# 162 Queens Quay East

Detailed Design

Review Stage: Detailed Design

# May 2019 DRP- Consensus comments

STREET VIEW

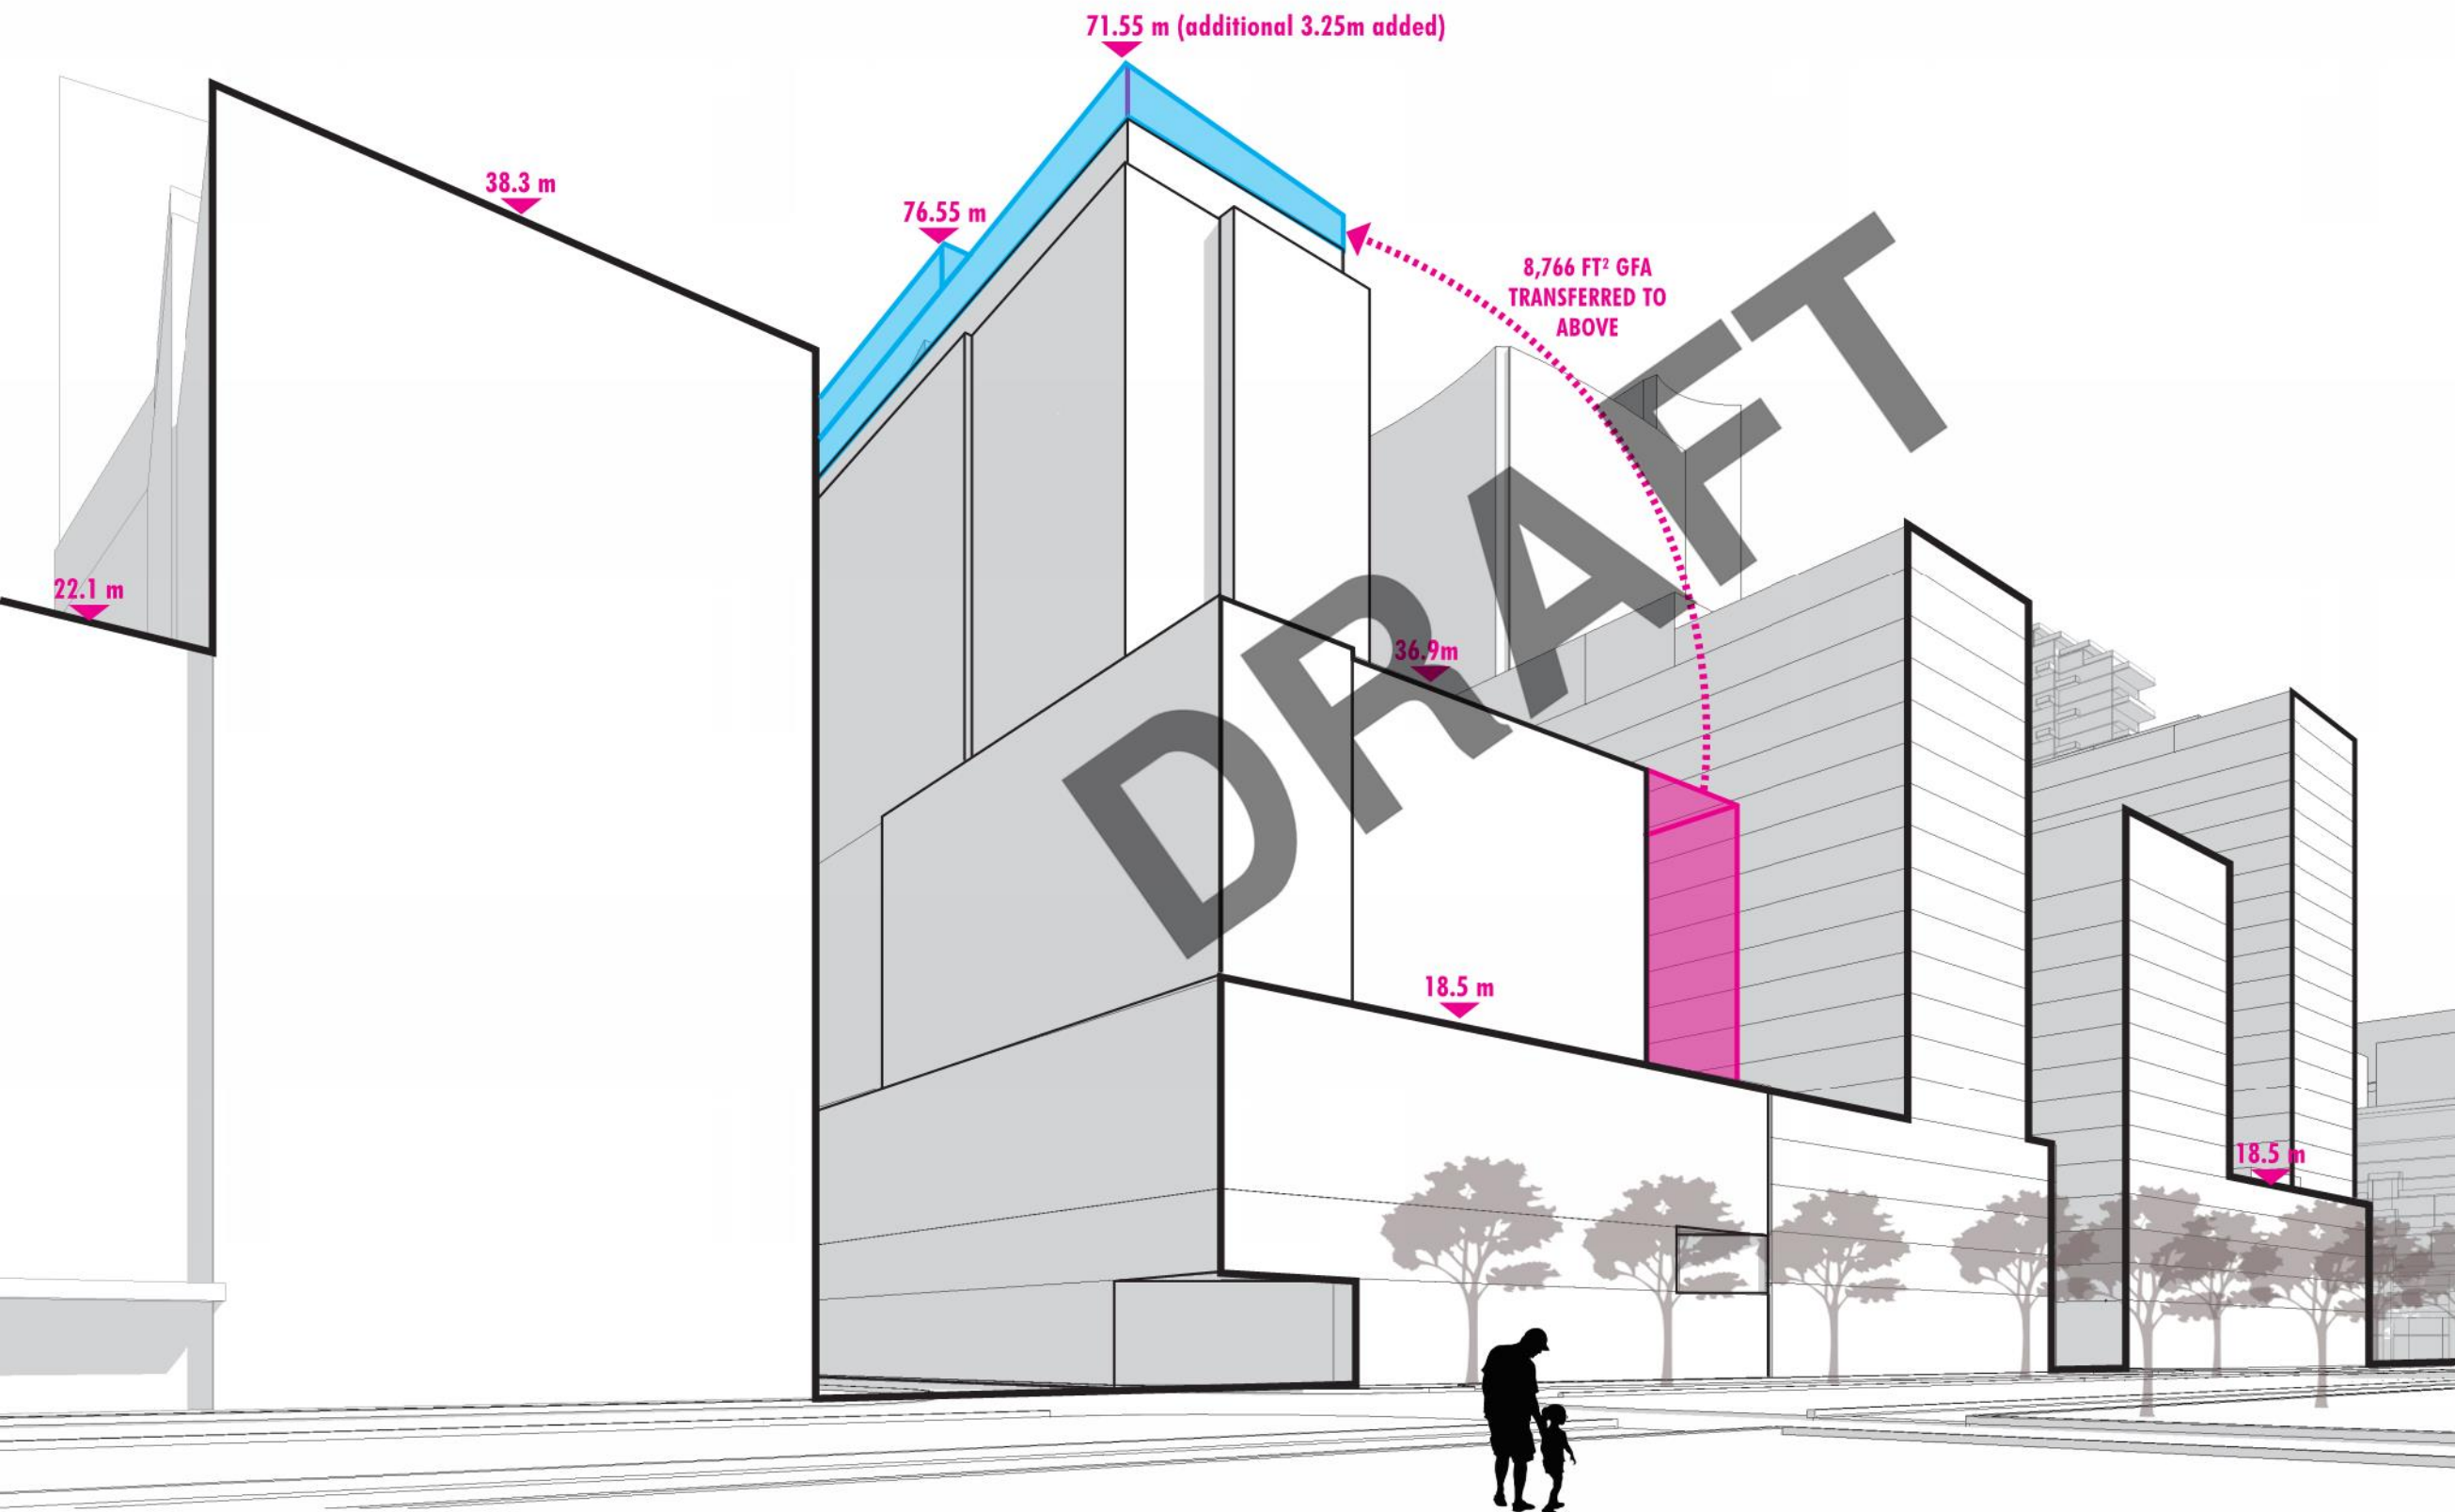
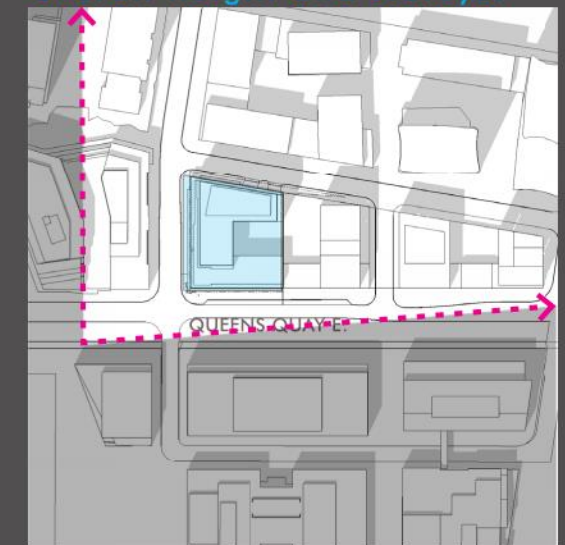
\*made during 178 Queens Quay E.  
1st DRP Meeting, July 24, 2019

- Consider a setback along the southeastern wing of the building (adjacent to 178 Queens Quay East) to create a larger setback between buildings.

- A 2m setback on the East would not create a noticeable impact. A 10m setback would create a huge loss in GFA that would add an extra storey to the building.
- A 10m setback would create a great loss of GFA from the podium. This would ultimately need to be added to the top of the building, increasing overall height and storeys.

**03 SITE MASSING**  
PEDESTRIAN VIEW OF CURRENT MASS

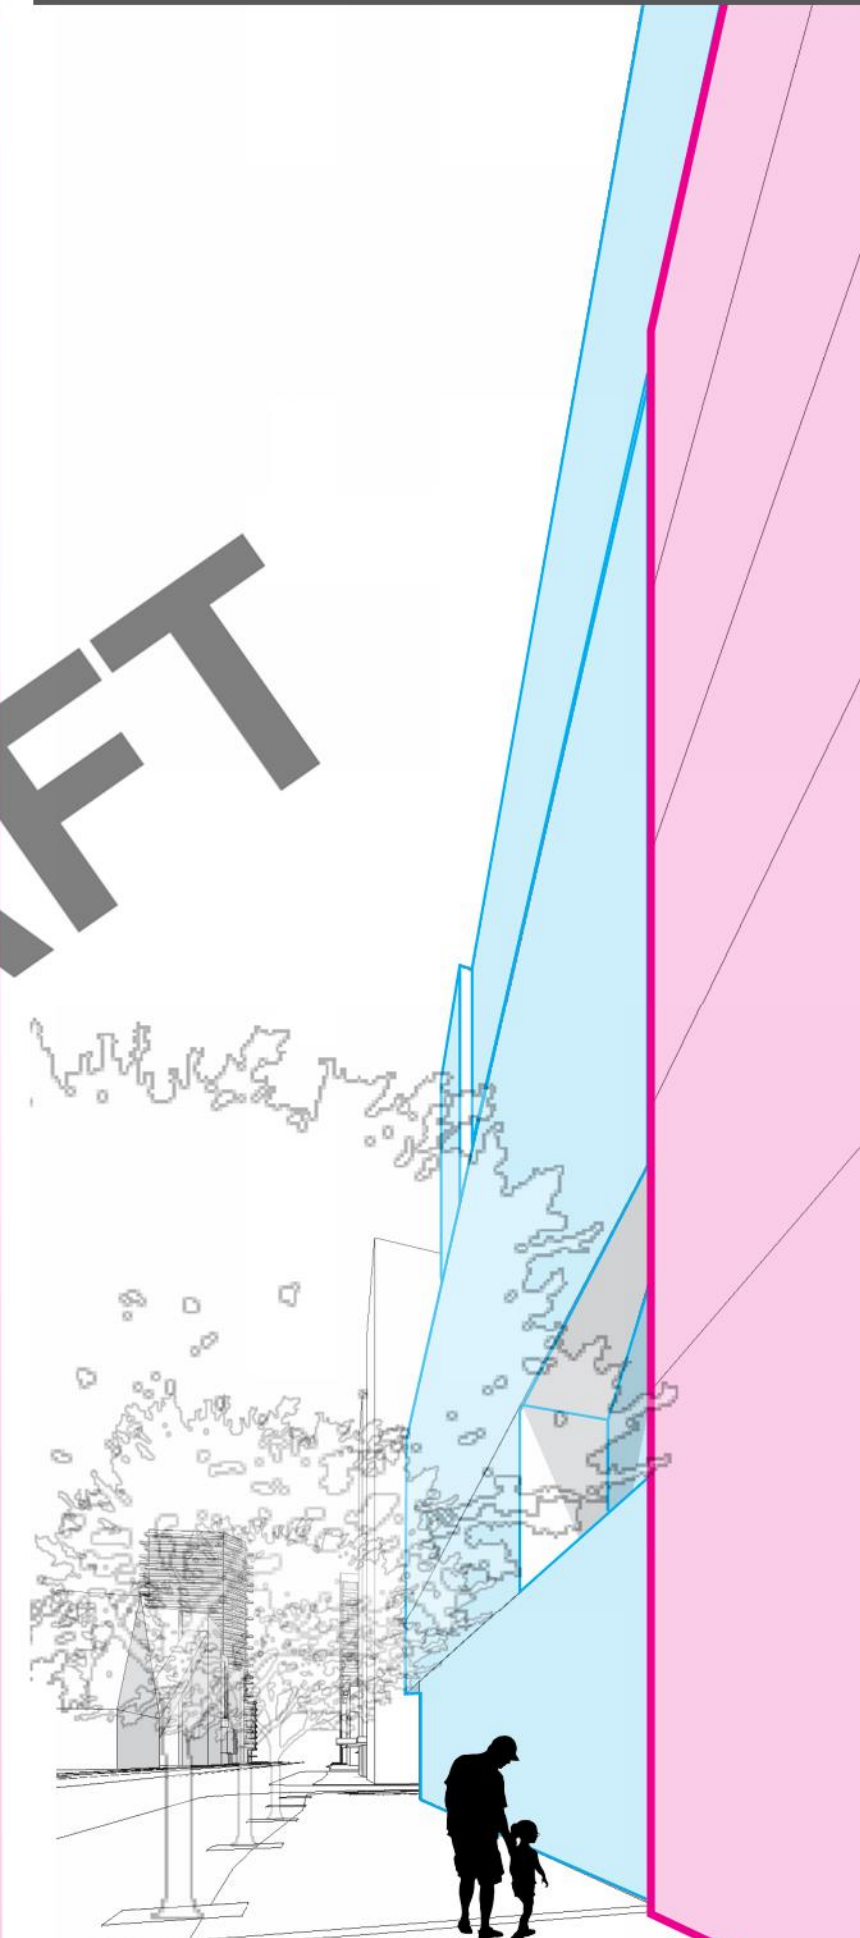
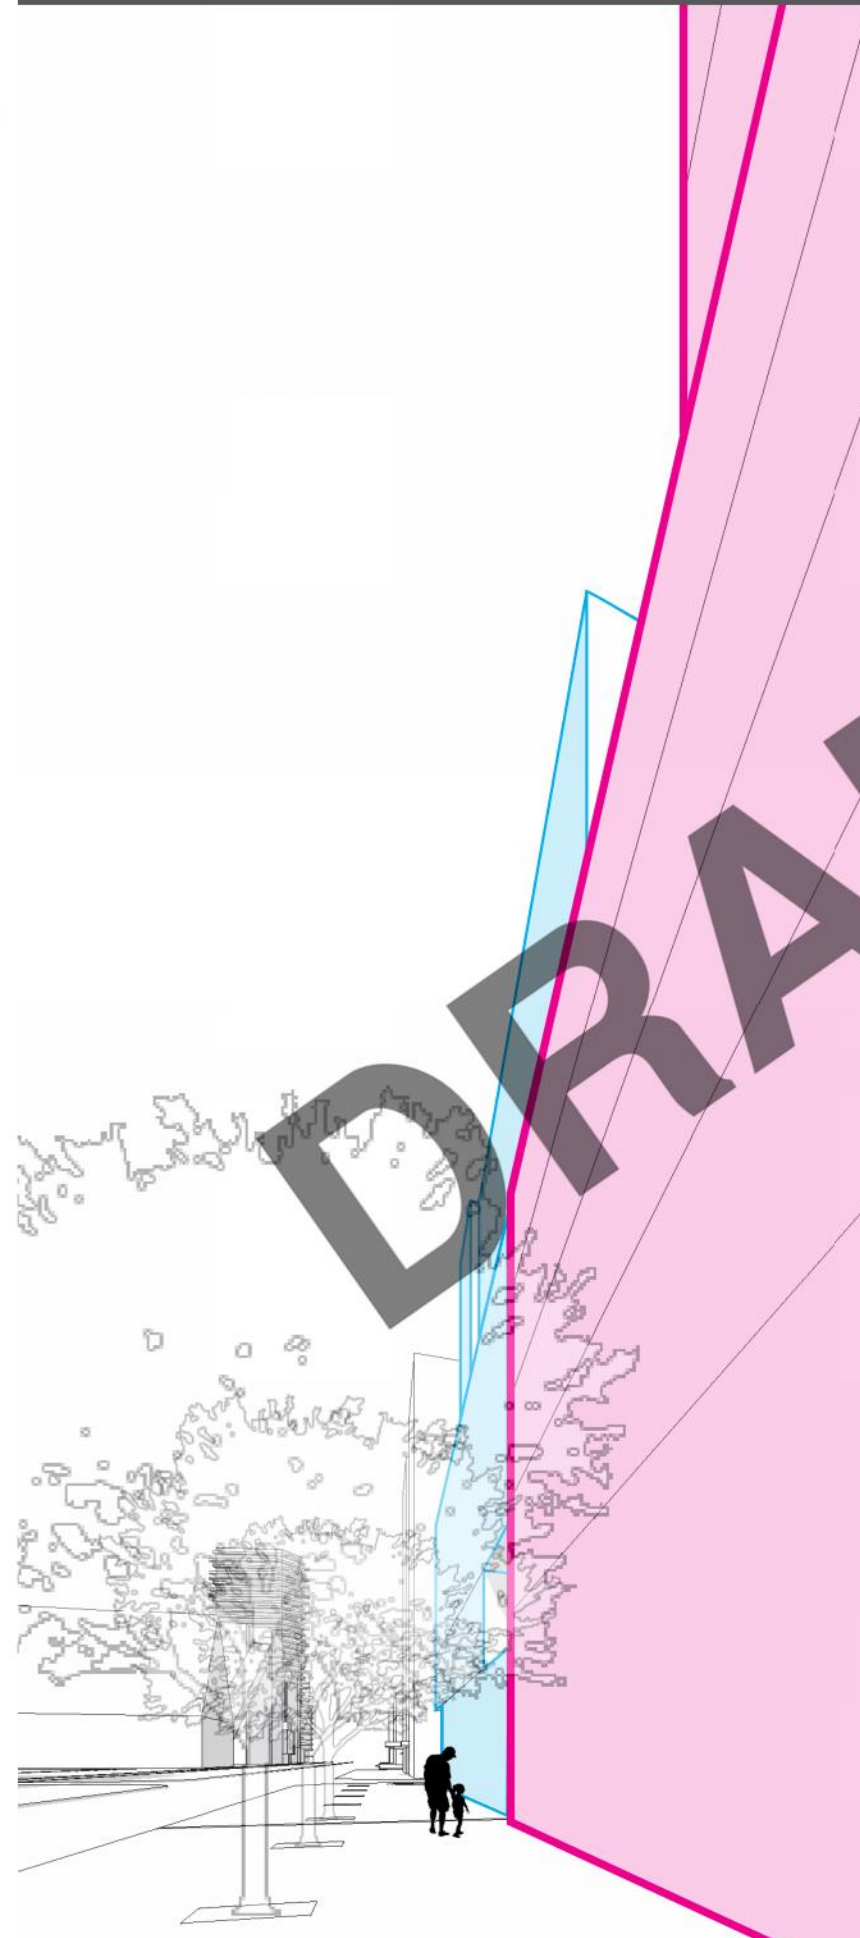
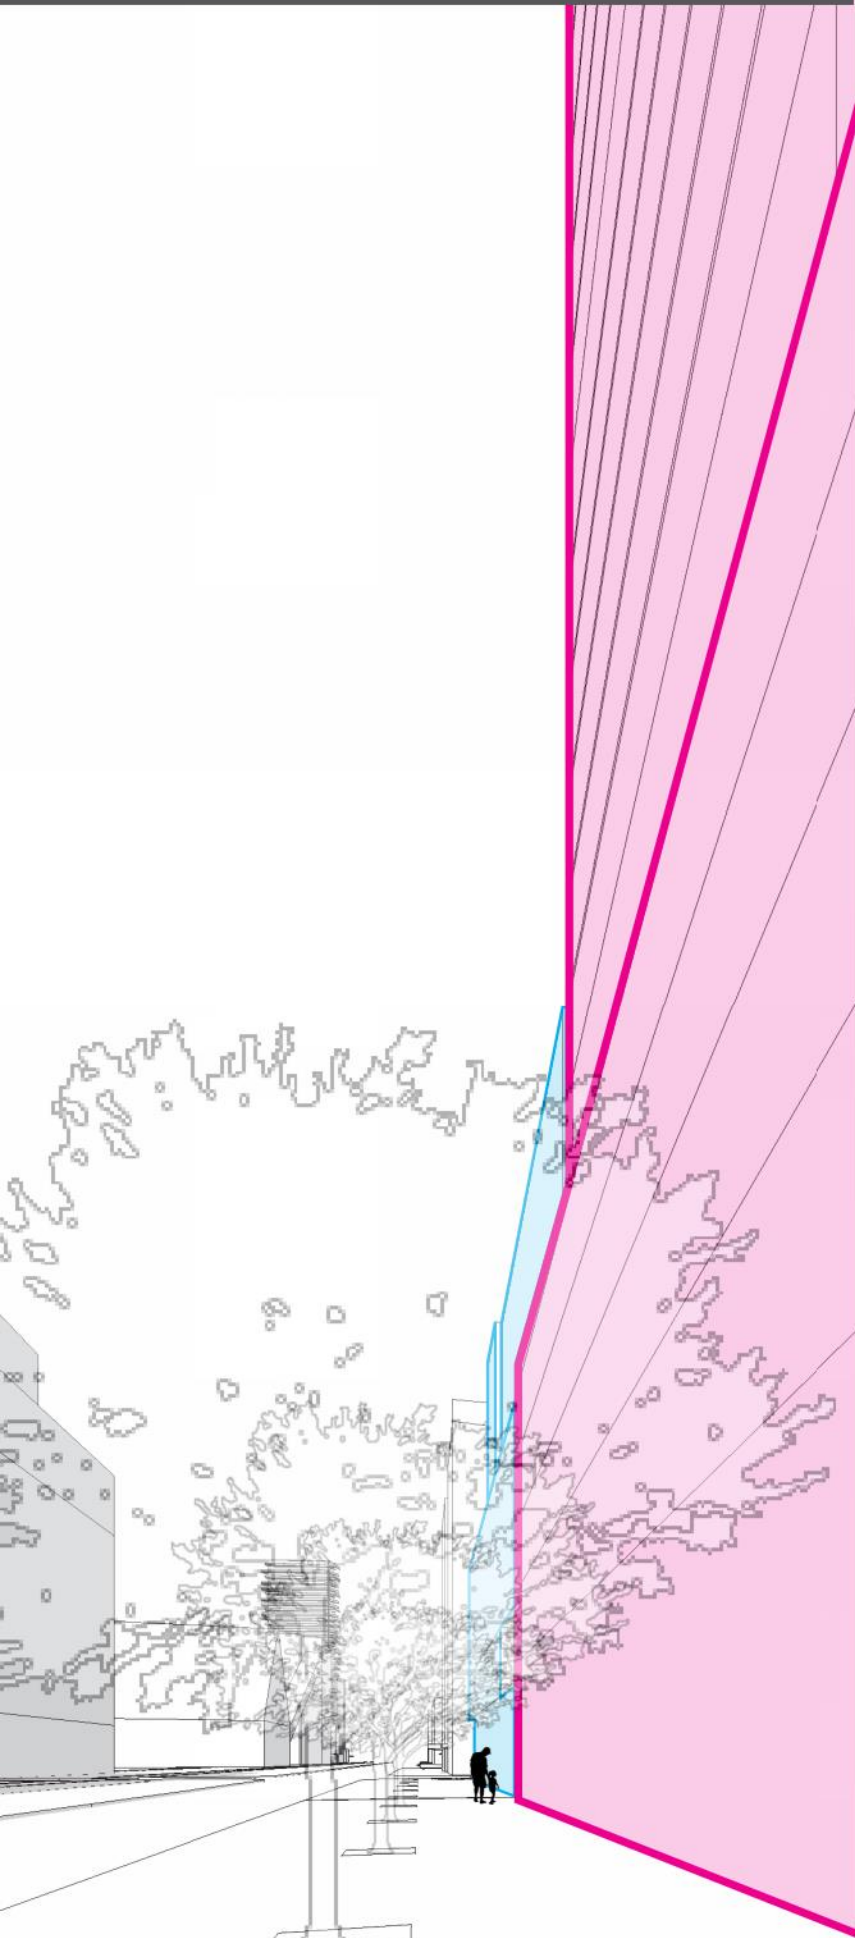
\*made during 178 Queens Quay E. 1st DRP Meeting, July 24, 2019

- Consider a setback along the southeastern wing of the building (adjacent to 178 Queens Quay East) to create a larger setback between buildings.

- The as-proposed massing of the podium does not impact the pedestrian realm along Queens Quay East. The distance between the buildings is not visible from street/pedestrian view and therefore the impacts are negligible.

## 04 | SITE CONTEXT

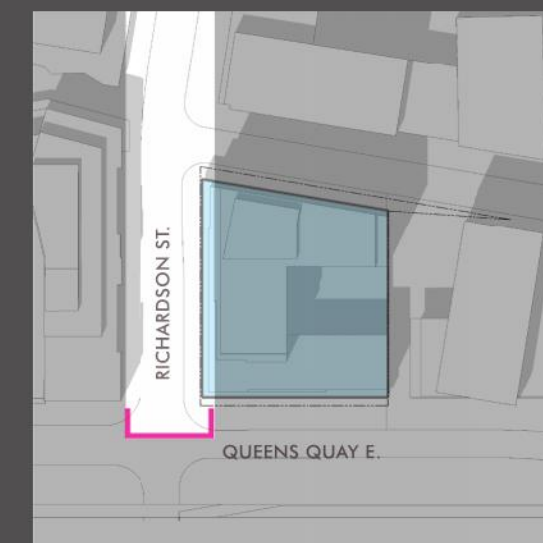
- Consider the relationship between the Daniels development and 162 Queens Quay

- The massing and materiality of 162 Queens Quay East compliments the massing of the Daniels development. Additional stepbacks on 162 Queens Quay East add variability and interest to the streetscape.
